Addendum No. 1
City of Coquitlam
Tender No. 72497
Johnson MUP and Atlantic Sidewalk Rehabilitation
 (Consists of 8 Pages)

Issue Date: April 22, 2026

Project **JOHNSON STREET MUP REHABILITATION**
 Description **ROADWORKS - PLAN**
 File: 25-0704-R1-1
 REV. 1

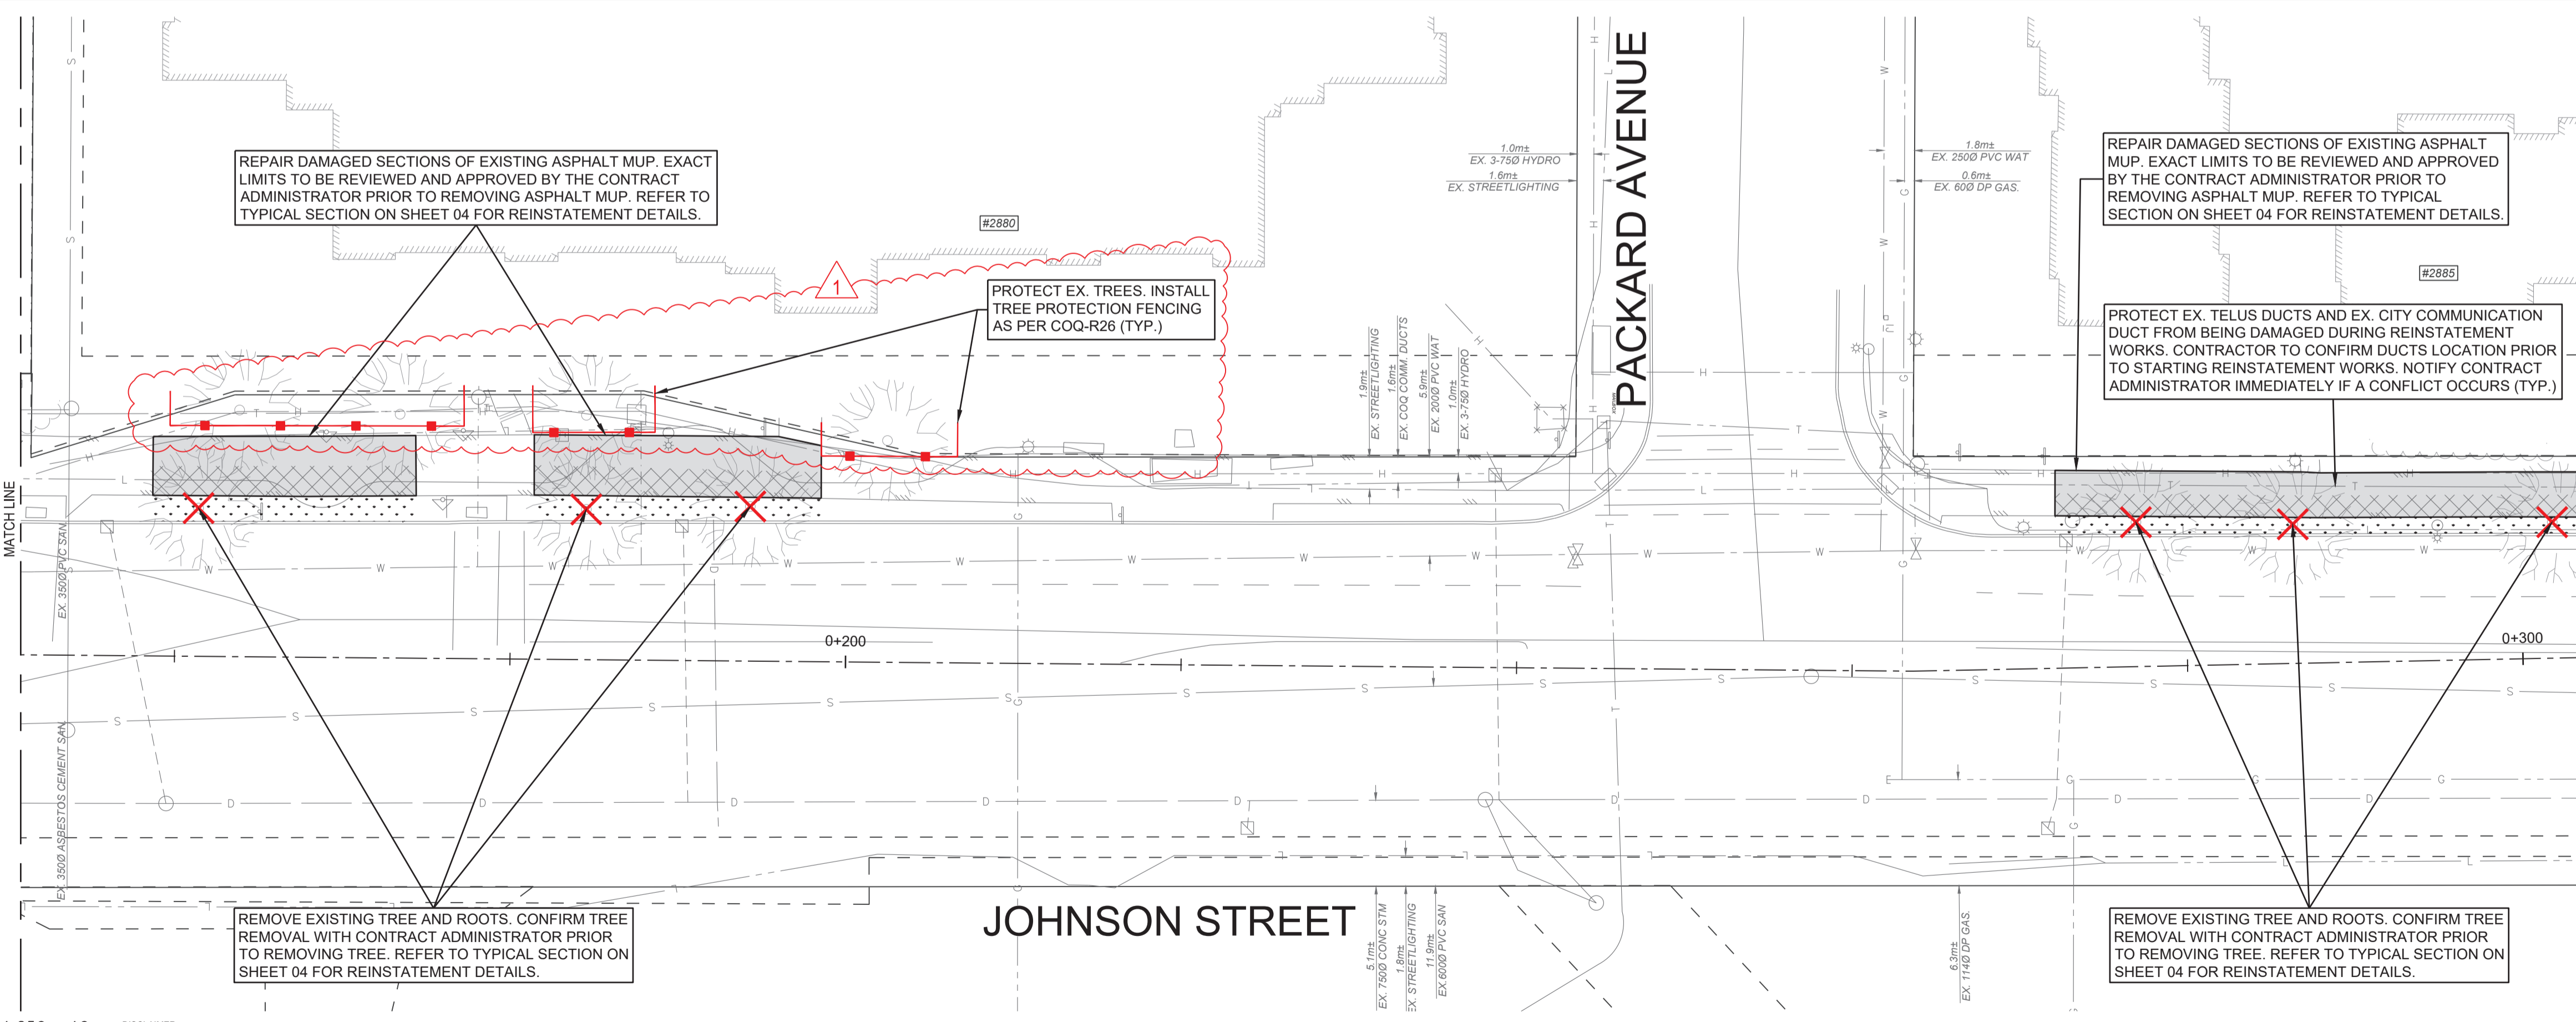
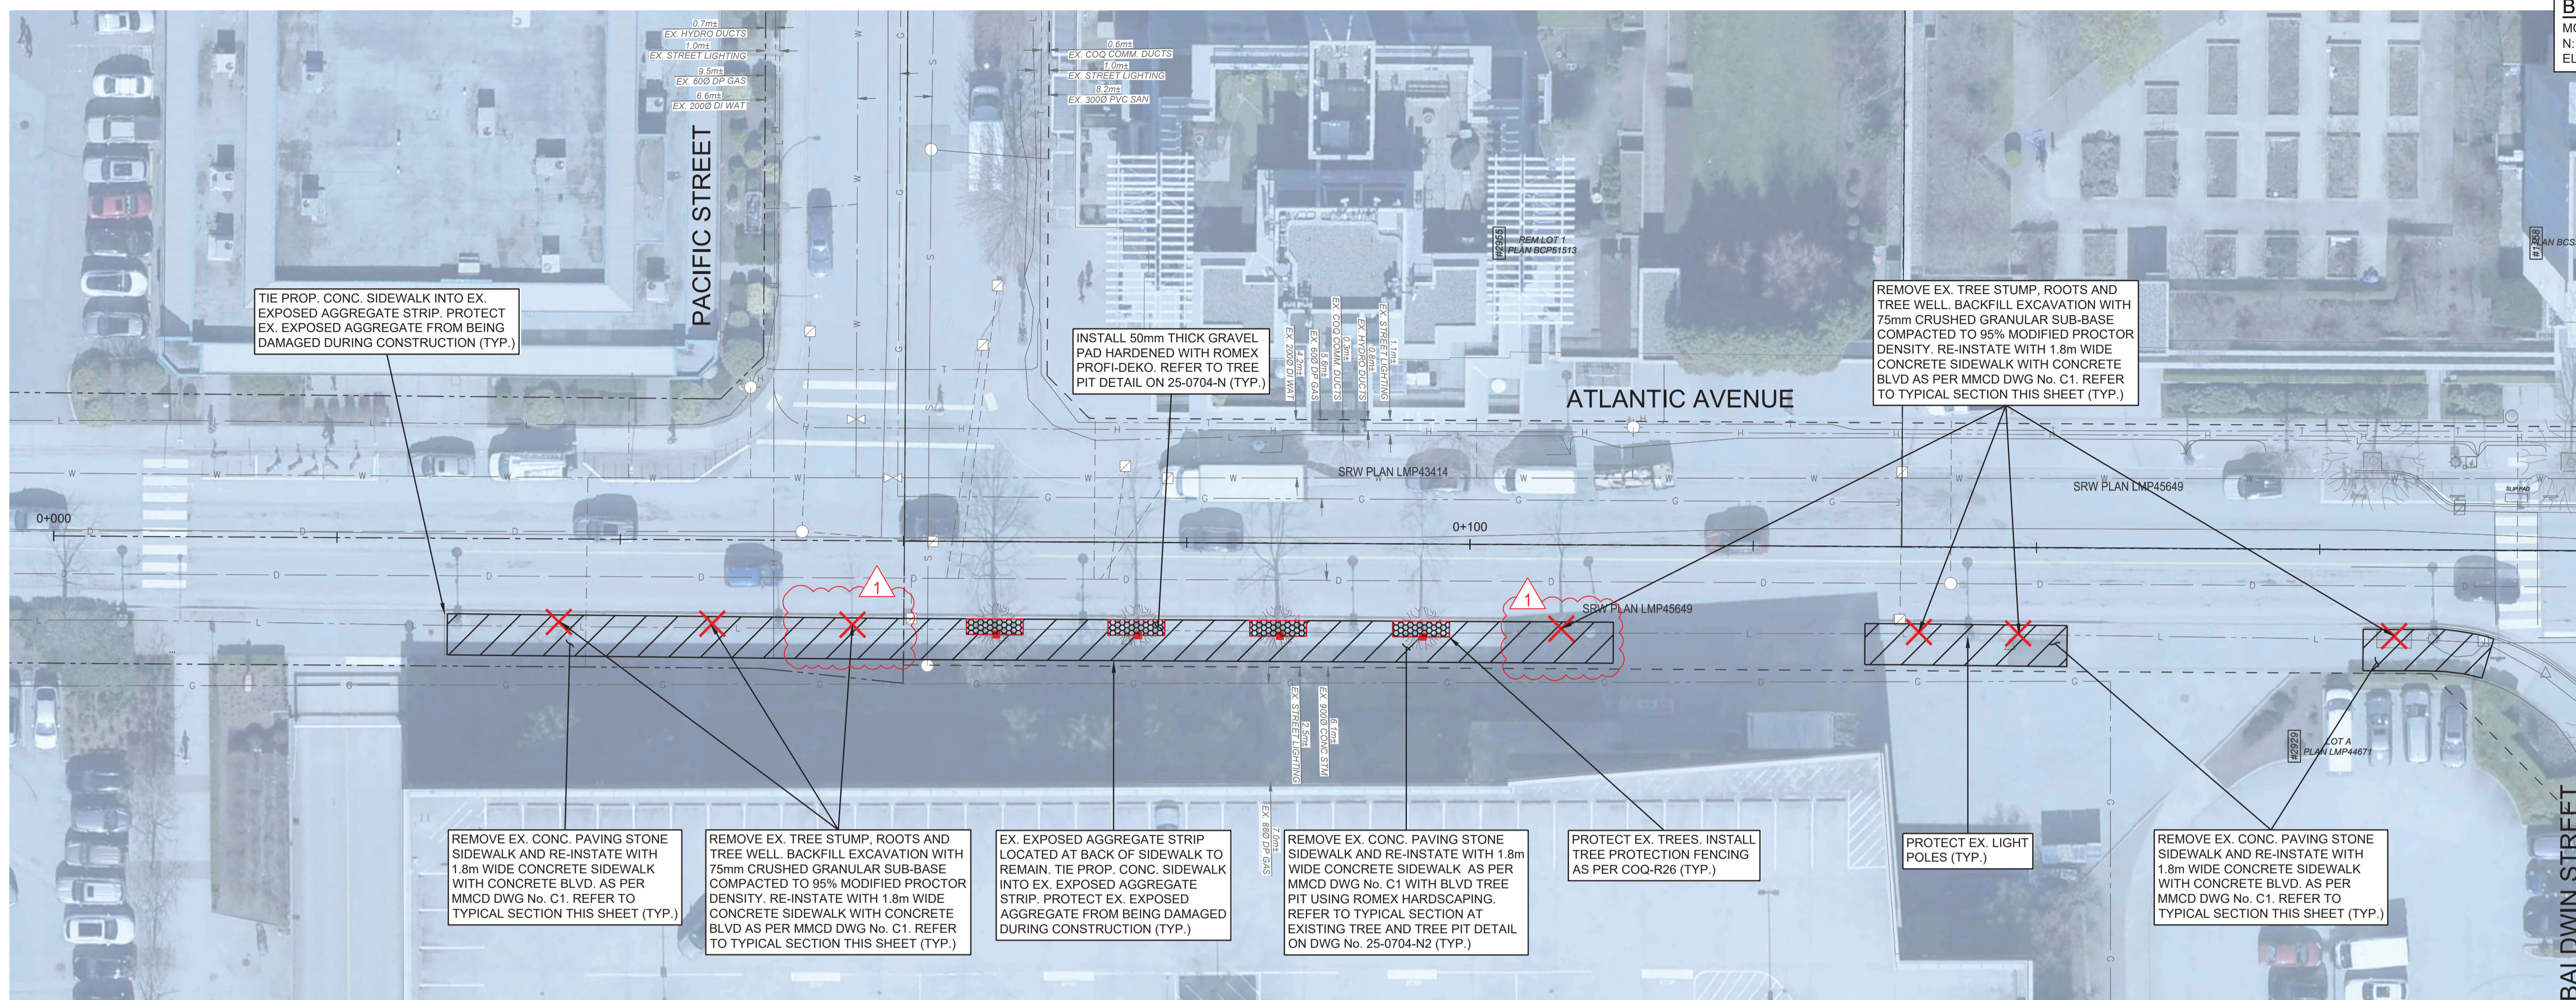
Q2) The arborist report shows tree fencing along Johnson Street, but the SOQ does not have any tree fence item for Johnson. Can you confirm that no tree fencing will be required along Johnson Street?

A2) Tree protection fencing will be required on Johnson Street. Please see revised drawings and *Revised – Appendix 1 – Revision No.1*.
